COUNTRY DOCTOR

MEDICAL CLINIC & APARTMENT HOUSING
510 19TH AVENUE EAST

DESIGN REVIEW RECOMMENDATION MEETING #2 - April 12th 2017
EAST DESIGN REVIEW BOARD- DPD PROJECT # 3019411

RESPONSE TO BOARD

FACADE COMPOSITION - SOUTH ELEVATION

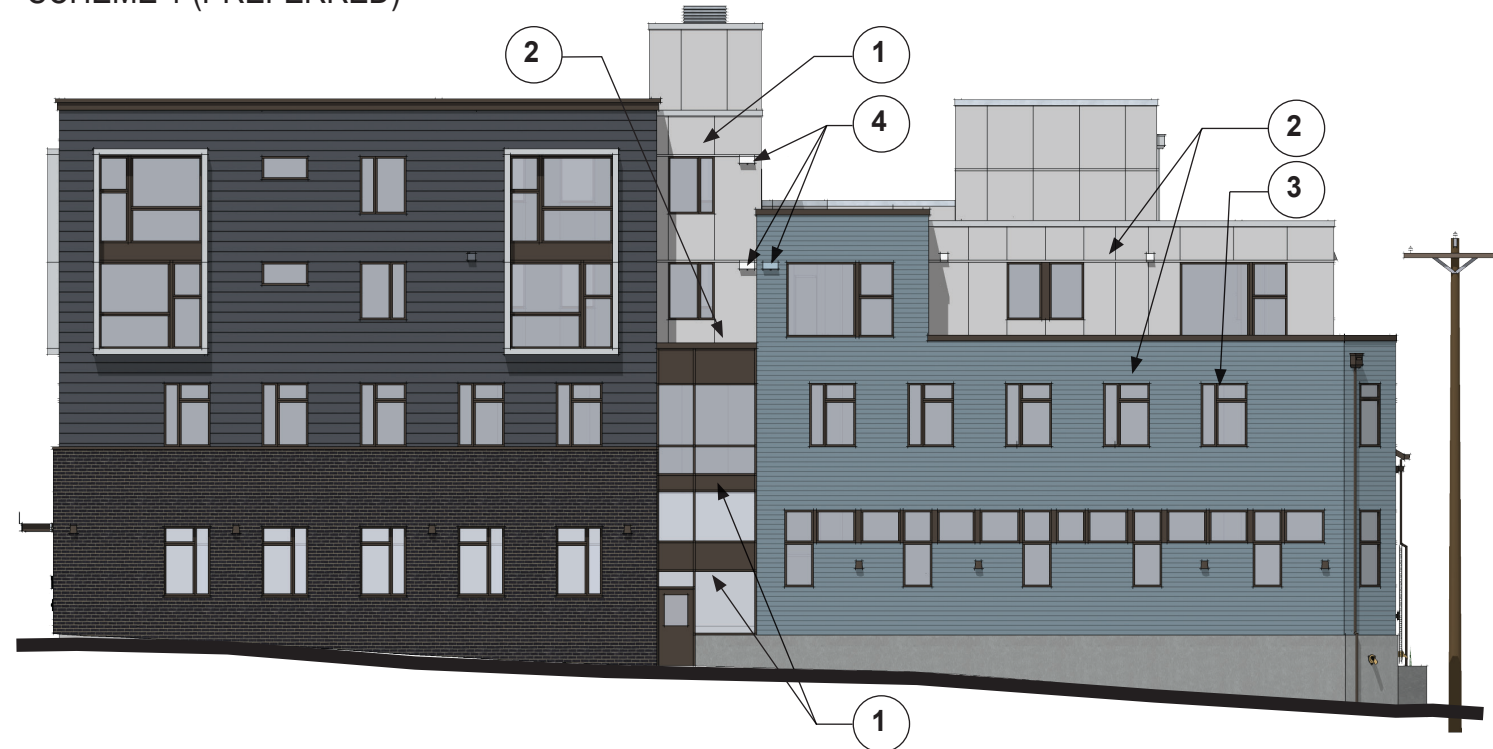
- A. GENERAL DESIGN CLARITY (BUILDING MASSING, GASKET EXPRESSION)
The south elevation has the appearance of two masses, separated by a vertical application of glazing. The Board described this condition as a type of transparent gasket that successfully breaks down the perceived mass of the structure. In further refinement of the façade composition, maintain this gasket expression. (DC2-C, DC2-D)

- B. USE OF COLOR
Again, in discussing the south elevation, the Board noted the architect’s intent of a commercial character for the front mass and a residential character for the rear. The Board supported this concept, but questioned whether it was necessary. Agreeing with public comment, the Board recommended the application of lighter colors at this south elevation to ensure the maximization of light. This lighter color application should also wrap to the east elevation. (DC2-C, DC2-D)

- C. HORIZONTAL EXPRESSION OF EAST VOLUME
The east volume proposed a window pattern with a strong horizontal expression at the first and second floors. The Board supported this fenestration alignment, but expressed concern that the horizontal language did not respond to the window patterns above. The Board recommended a stronger relationship of all windows on the south elevation of the east volume (DC2-C, DC2-D).

- D. VENT LOCATIONS
The Board requested vent locations be shown on all elevations (DC2-C, DC2-D).

1. Building Massing, Gasket Expression - The general approach towards the building's massing has remained, with a glazed gasket separating the front (public) half of the building from the rear (private) half. The amount of glazing within the gasket has been reduced in response to programmatic and cost constraints (opaque metal panels are proposed where glazing was illustrated in the pervious scheme). The color of the painted siding in the gasket area has been lightened (to enhance the gasket expression up through the top of the building).

2. Use of Color - Lighter paint colors are now proposed for the siding occurring above both the glazed gasket and rear half of the building.
3. Horizontal Expression of East Volume - The horizontal accent bands of siding at the east volume of this facade have been removed, and the window configurations at the second floor level have been revised to provide a composition with vertical proportions. A single window type is now proposed for all second floor clinic spaces, and the proportions of this window type are derived from the first floor clinic windows that occur in the brick veneer.

4. Vent Locations - The locations of wall vents occurring at the south facade have been indicated (see above and Colored Elevations on page 12).

FACADE COMPOSITION - EAST ELEVATION

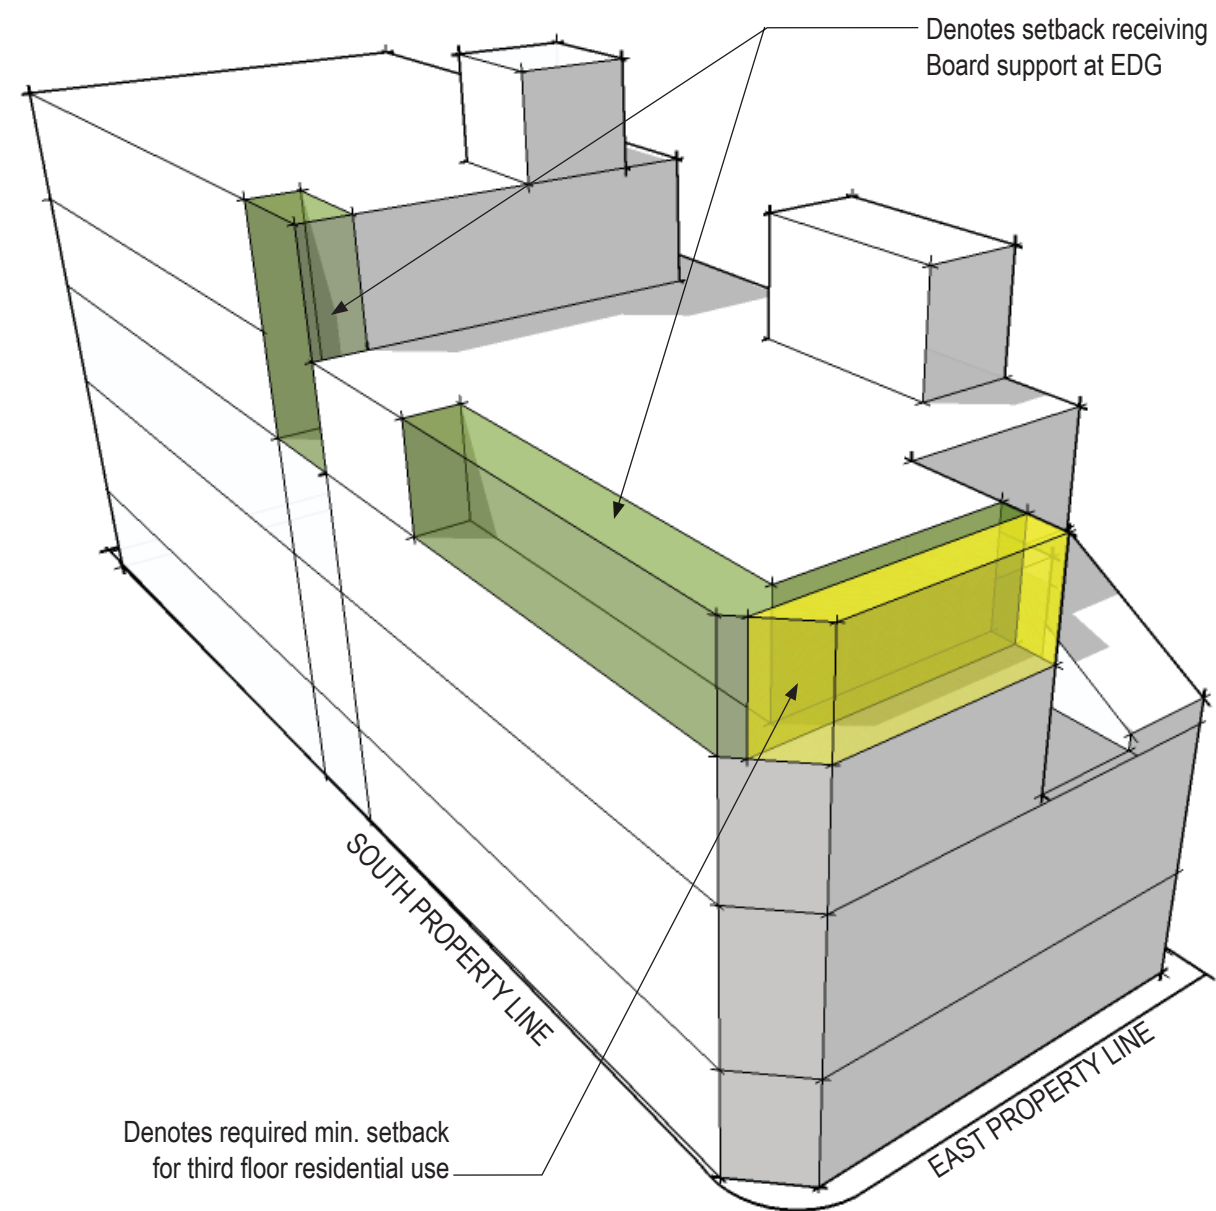
- A. **ACTIVATION OF NORTH/SOUTH ALLEY**
In response to the Board's EDG guidance to activate the adjacent (north-south) alley, the proposal included an intricate metal screen, door, and green screen at the ground level. The Board supported the graphic metal screen, door, and green screen, but questioned the viability of plants on the east elevation. To mitigate this concern, the Board recommended reducing the size of the green screen to wrap the door only, rather than span the width of the metal screen. The Board requested vent locations be shown on all elevations. (CS2-B, PL1-A, DC2-B, DC2-D)

1. Green Screen - The extent of proposed green screen has been limited to the wall area directly above the (2) proposed planters.
2. Use of Color - Lighter paint colors are now proposed for the siding.
3. Facade Composition - Water jet-cut painted metal scale figures representative of the Country Doctor logo are proposed to occur at the sliding trash enclosure gates.
4. Vent Locations - The locations of wall vents occurring at the east facade have been indicated (see above and Colored Elevations on page 13).

SETBACK DIAGRAM @ SOUTH FACADE

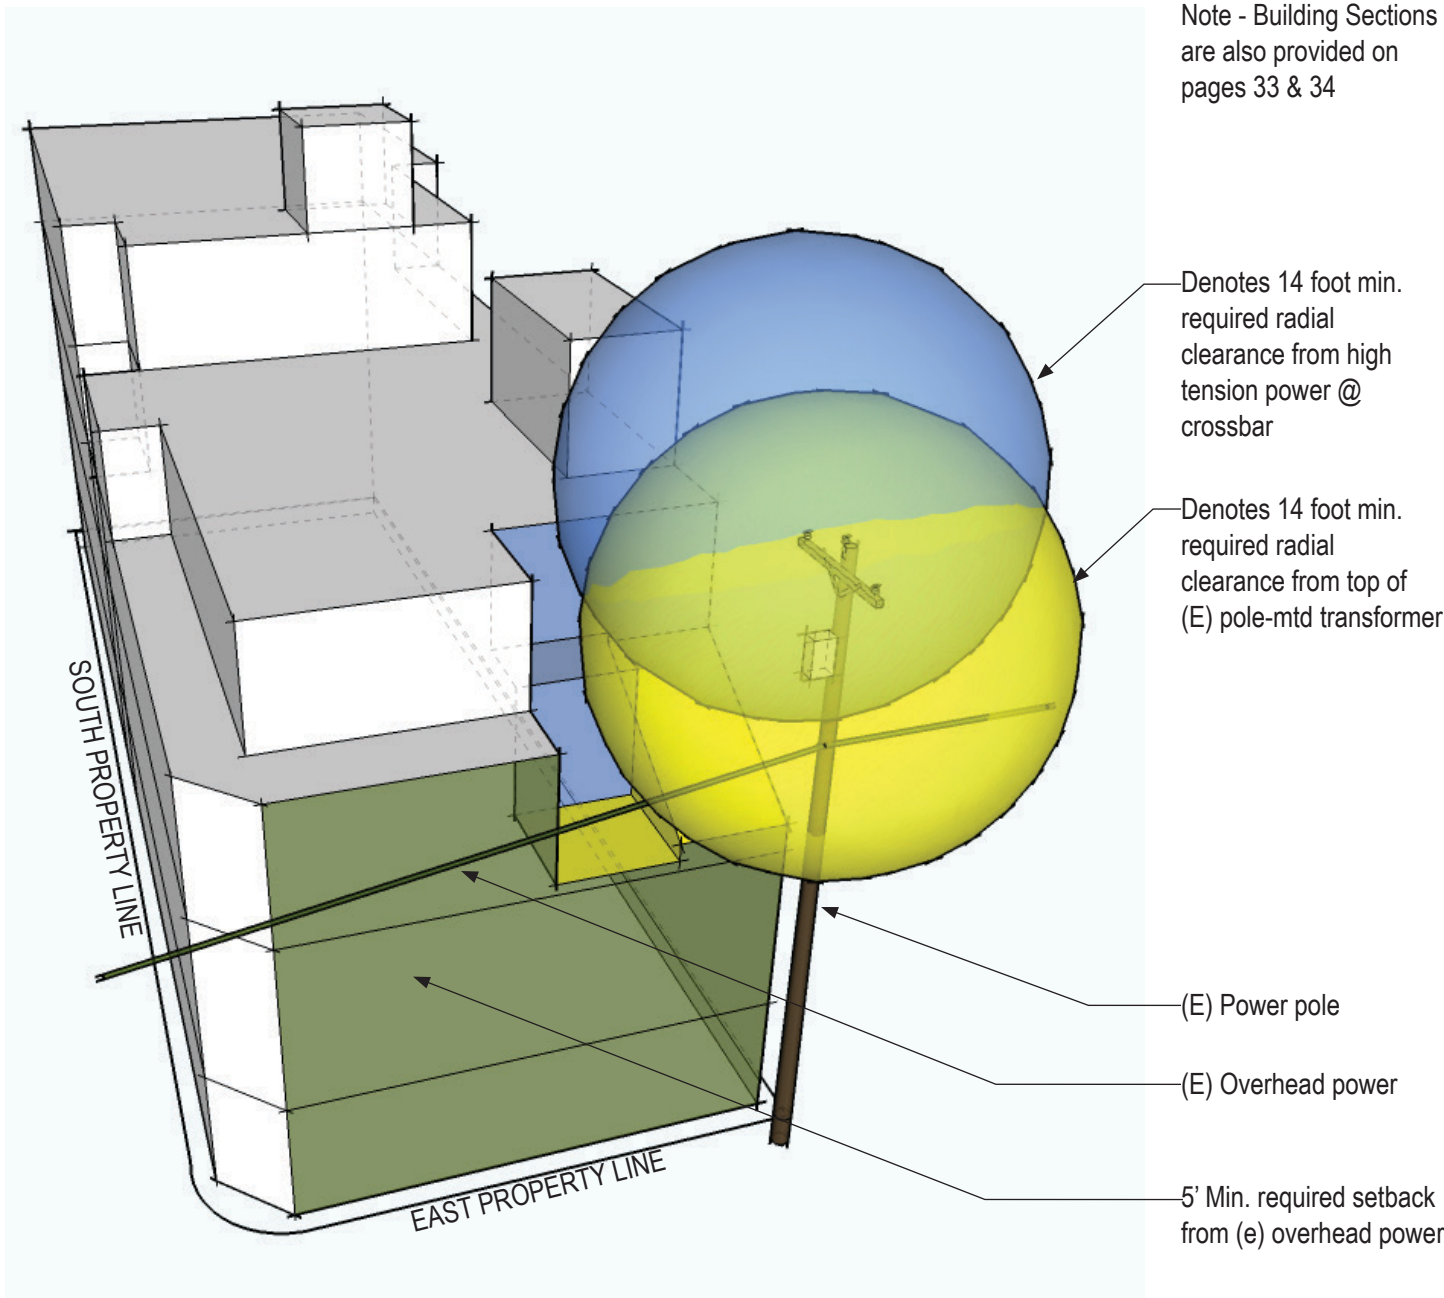
Guidance received from the EDG meeting was supportive of setting back the mass at the 4th floor residential levels. Additionally the setback at the gasket mass reinforces the divide between public and private facades of the building.

SETBACK DIAGRAM @ EAST FACADE

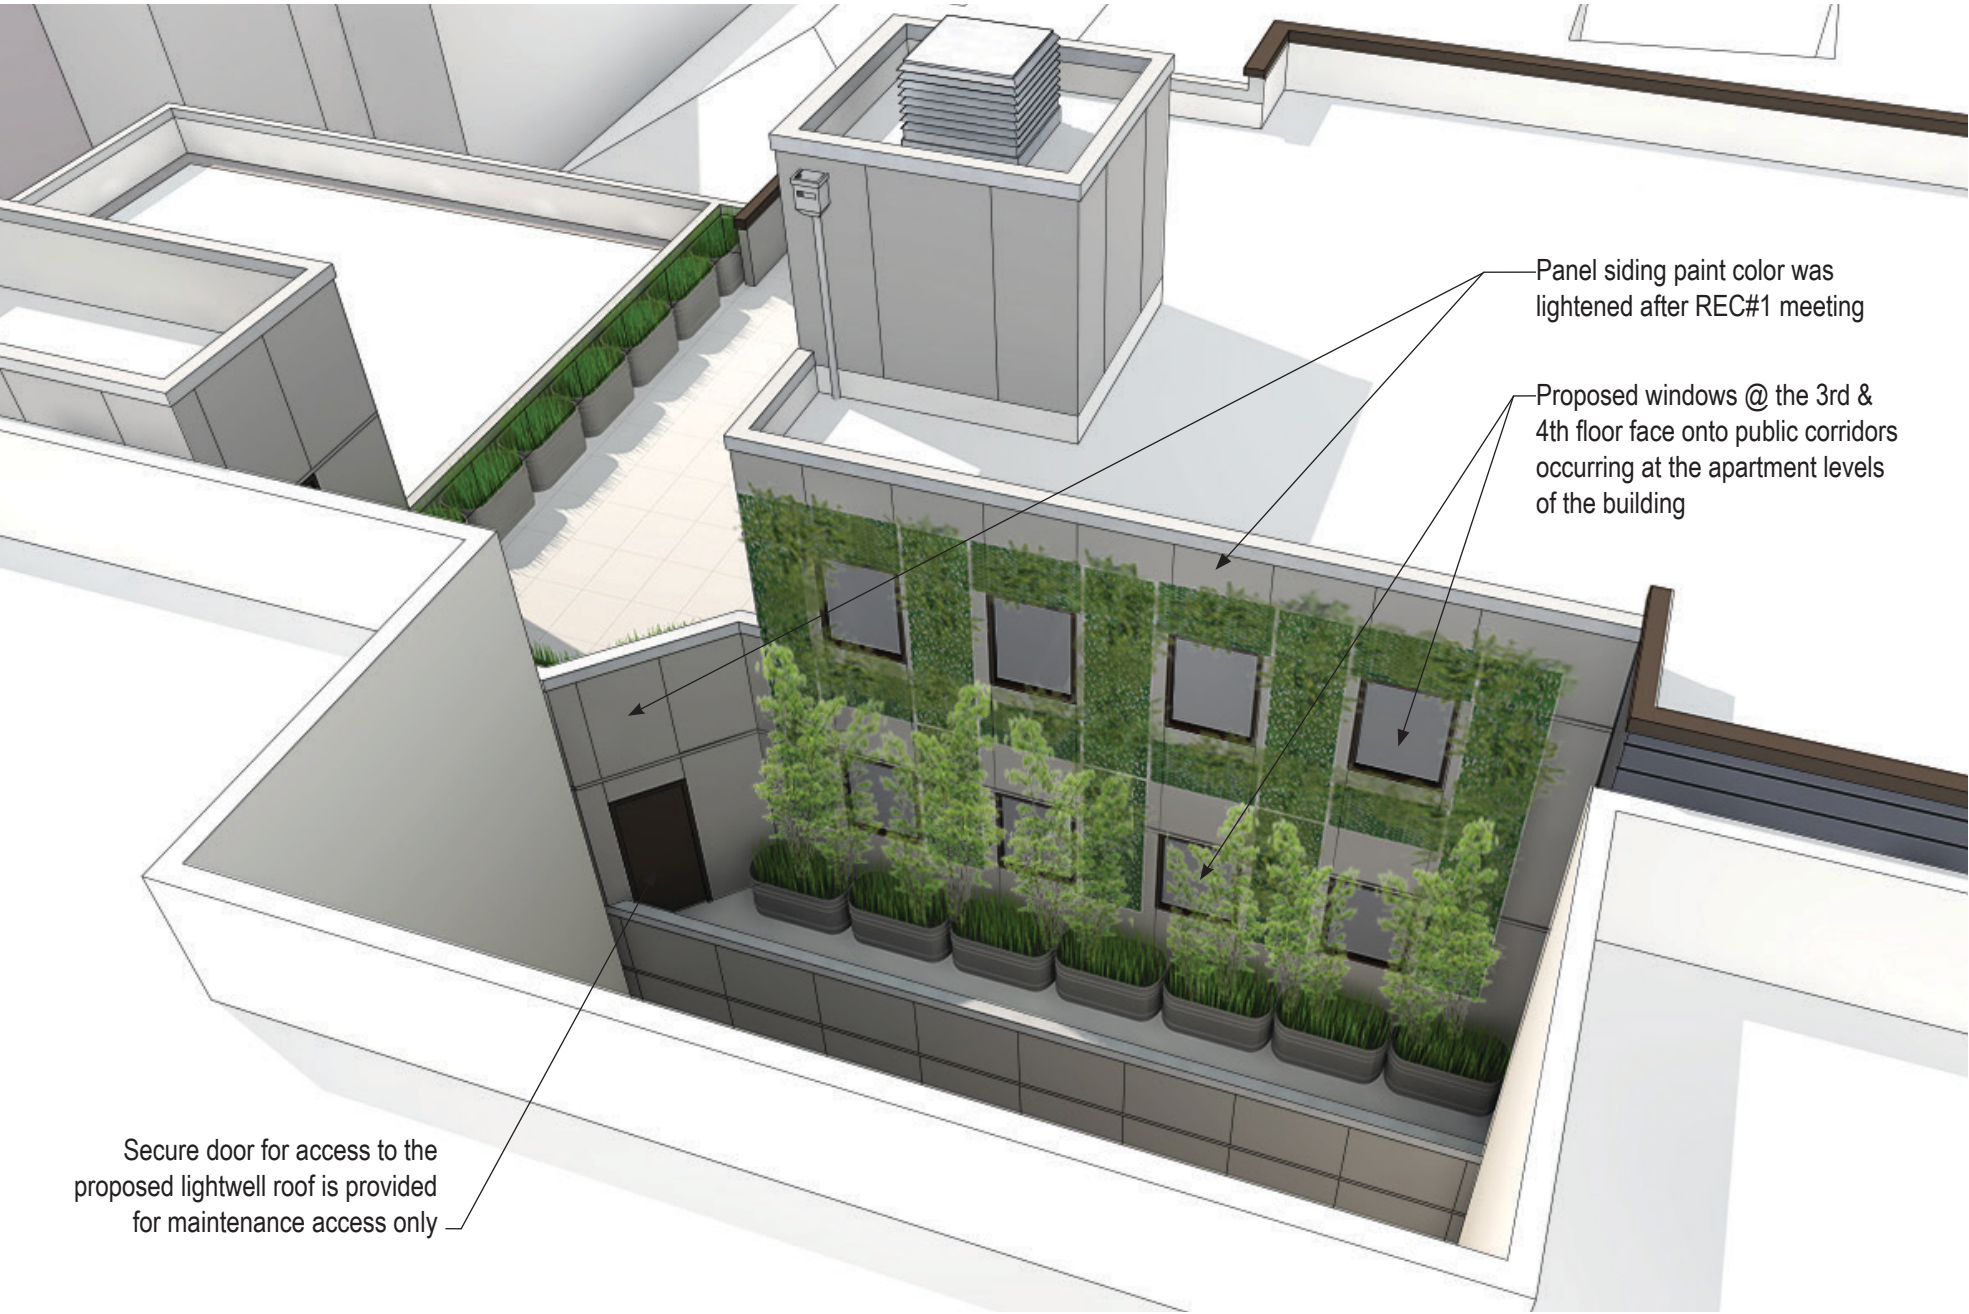
The massing of the east facade of the building is directly correlated to required setbacks from existing overhead power to remain, as well as programmatic necessities.

AERIAL VIEW LOOKING INTO NORTH LIGHTWELL

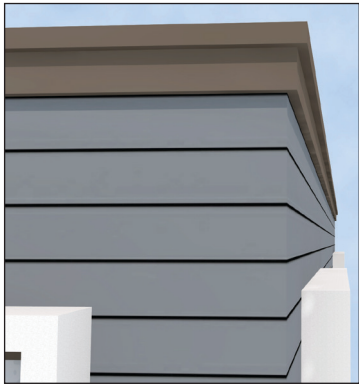
The structure adjacent to the north has a light well providing sunlight to residential units. In response to this condition and Board guidance from the EDG meeting, the massing responds with setbacks to allow natural light to continue to penetrate into this space. A green screen is also proposed to soften the appearance of the proposed new construction. Additionally, privacy concerns are mitigated by avoiding direct unit to unit visibility. The Board supported this response. (CS1-B).

The physical design of this area has not changed since the REC#1 meeting, but the paint color has been lightened in response to community feedback.

Secure door for access to the proposed lightwell roof is provided for maintenance access only

WEST ELEVATION

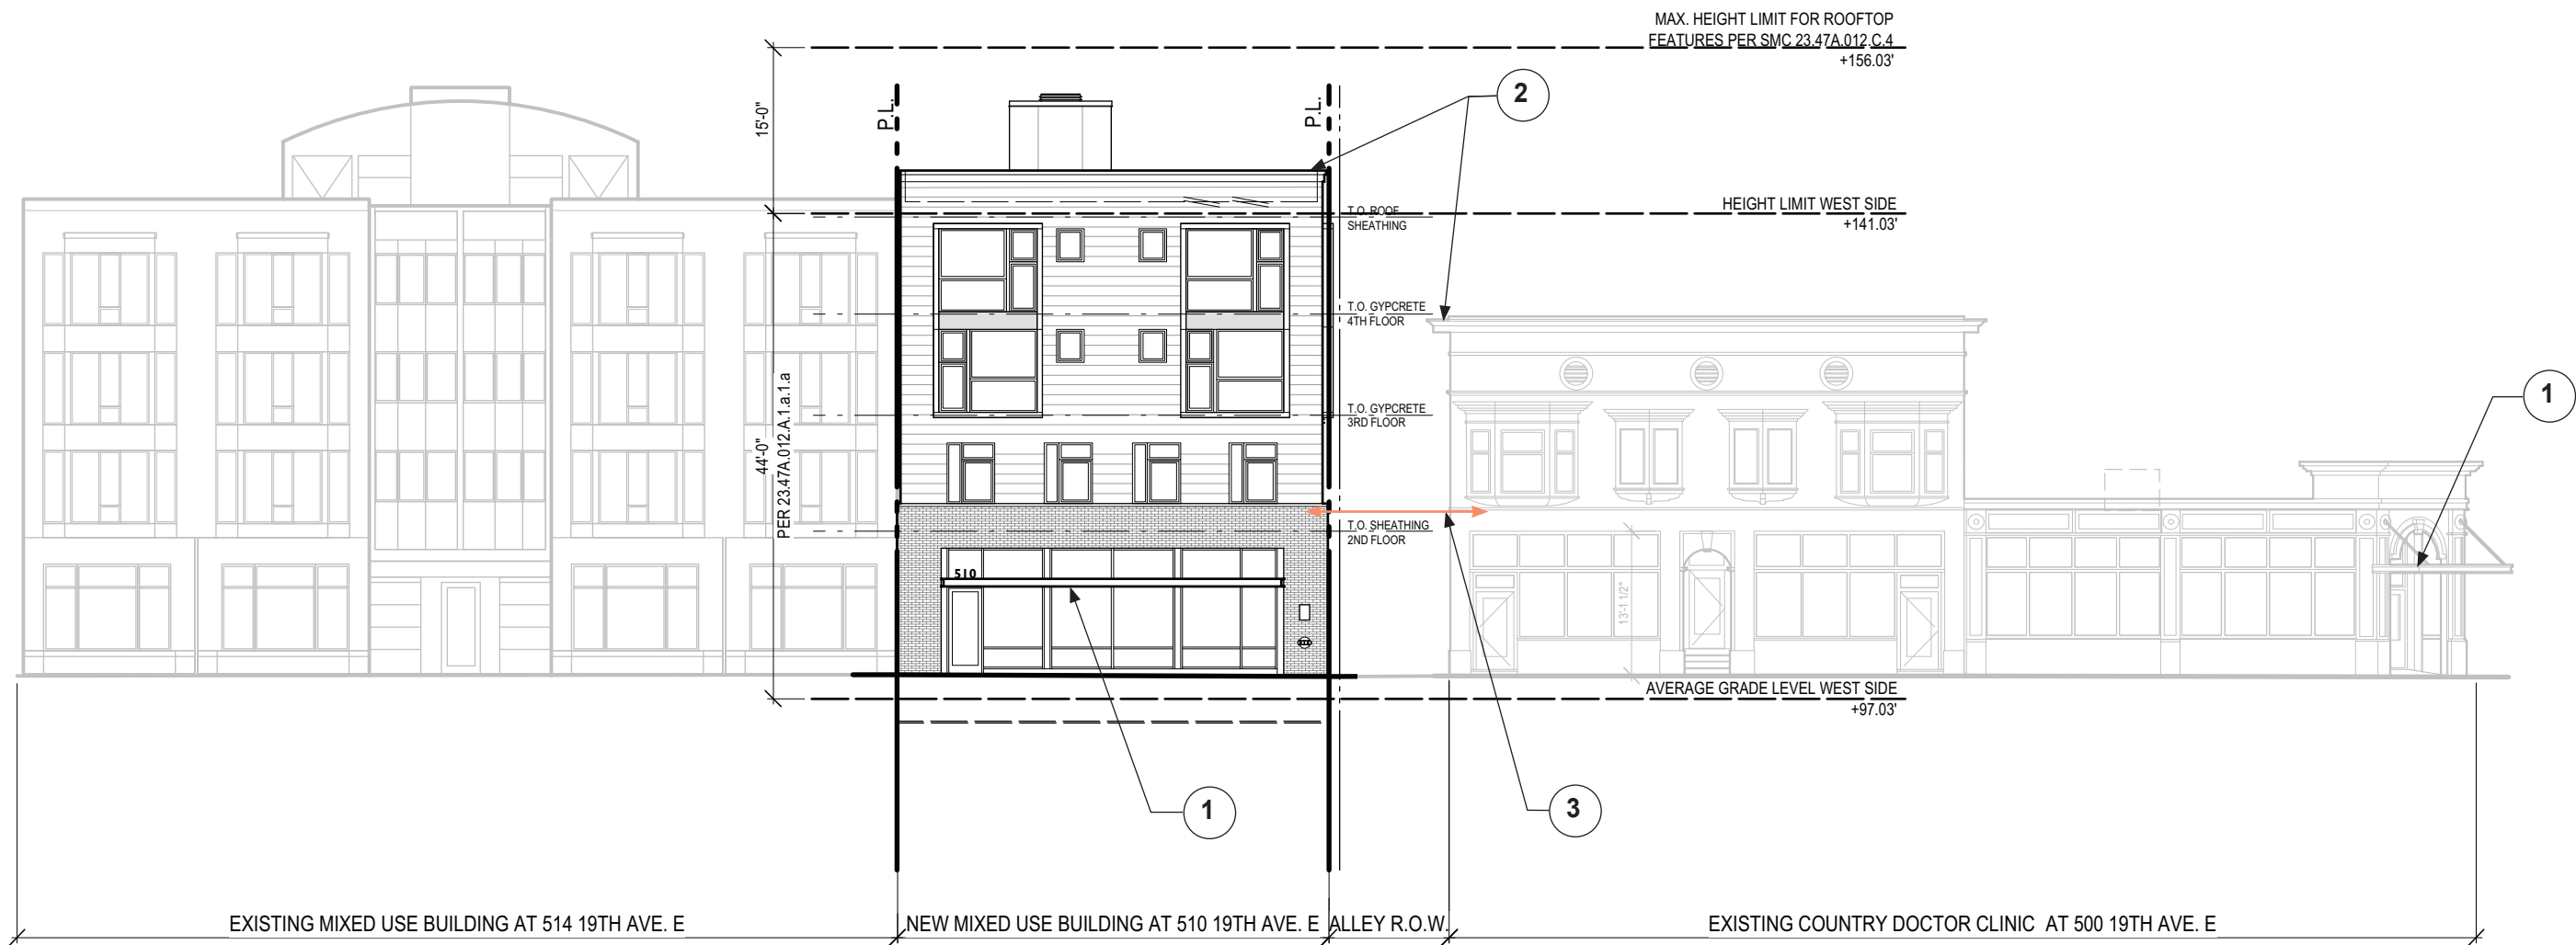
- B. **RESPONSE TO ADJACENT CONTEXT**
The Board was not convinced that the façade composition was a successful response to the adjacent context. Include in the packet elevations that include adjacent structures.

1 The canopies @ both Country Doctor clinics are both constructed of painted steel channels

2 The proposed protruding coping responds the neighboring existing Country Doctor Clinic at 500 15th Avenue East

3 The proposed brick veneer now aligns with stucco accent band @ 500 15th Avenue East
